**From:** Beggs, Tauren R - DNR  
**Sent:** Friday, September 16, 2022 9:13 AM  
**To:** Adam Tegen  
**Cc:** Cull, Whitney; Byers, Harris  
**Subject:** Material Management Plan Approval Letter for River Point District - LGU, BRRTS # 02-36-585491  
**Attachments:** 20220916\_857\_MMP\_Appr.pdf

Subject: Approval to Manage Contaminated Soil On-Site under Wis. Admin. Code § NR 718.12  
River Point District – LGU, North 10<sup>th</sup> Street and Buffalo Street, Manitowoc, WI 54220  
DNR BRRTS Activity # 02-36-585491

DATE OF ISSUANCE	07/13/2022
NO. REVISION	DATE
SURVEY	CENTERPOINT
DRAWN	JAW
DESIGNED	JAW
CHECKED	JCB
APPROVED	SMM
PROJ. NO.	193805824
SHEET NUMBER	<b>C3.02</b>

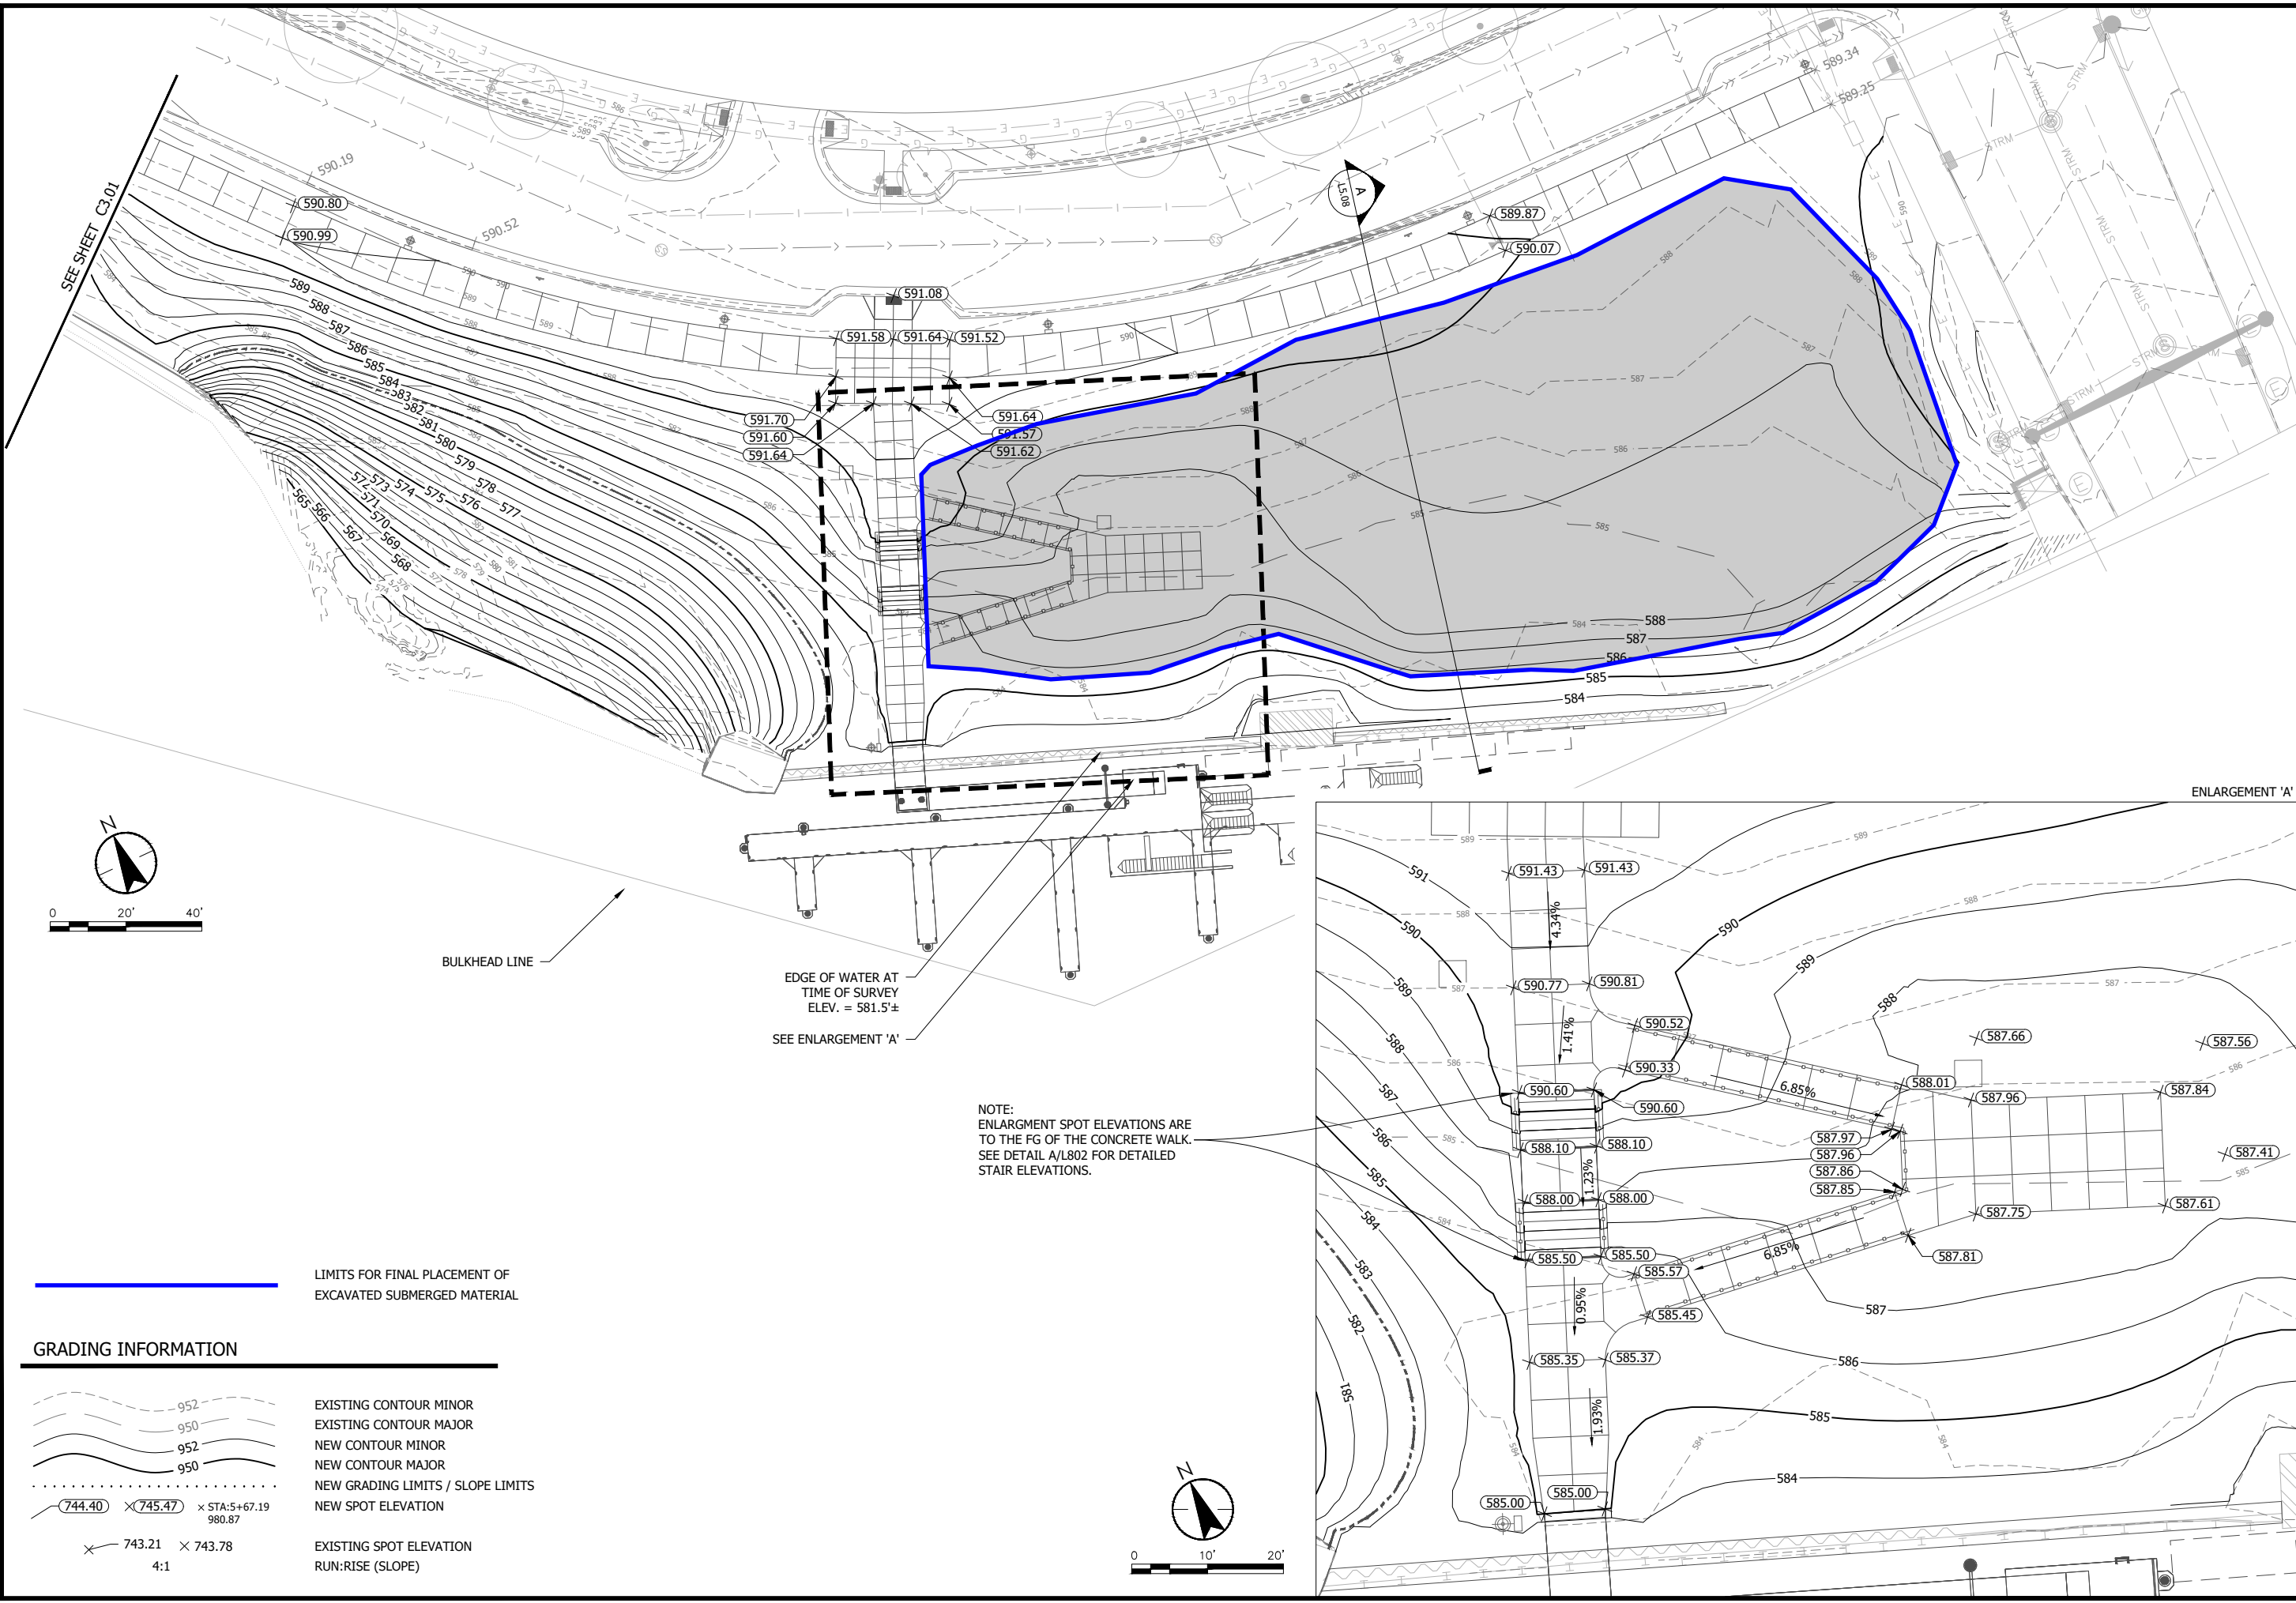
Managing contaminated soil in areas of the site identified on Sheet Number C3.02, Grading Plan, dated July 13, 2022, of the MMP will meet the locational criteria listed under Wis. Admin. Code § NR 718.12 (1) (c), except for the following:

If contaminated soil that is managed as proposed on Sheet Number C3.02, Grading Plan, dated July 13, 2022, of the MMP is excavated in the future, the property owner at the time of excavation will have the following responsibilities per Wis. Admin. Code § NR 727.05 (1) (d):

A maintenance plan must be provided to the DNR once the barrier has been constructed that must address actual site conditions per Wis. Admin. Code § NR 724.15 (3) (h). Sheet Numbers C1.01 and C1.02, Erosion Control Plan, dated July 13, 2022, and Sheet Number C3.02, Grading Plan, dated July 13, 2022, of the MMP attached shows where contaminated soil is proposed to be managed and the extent of the proposed cover. Once constructed, inspections of the impervious and pervious caps will be required per Wis. Admin. Code § NR 724.13), and submittal of inspection reports may also be required per Wis. Admin. Code § 727.05 (1) (b) 3.
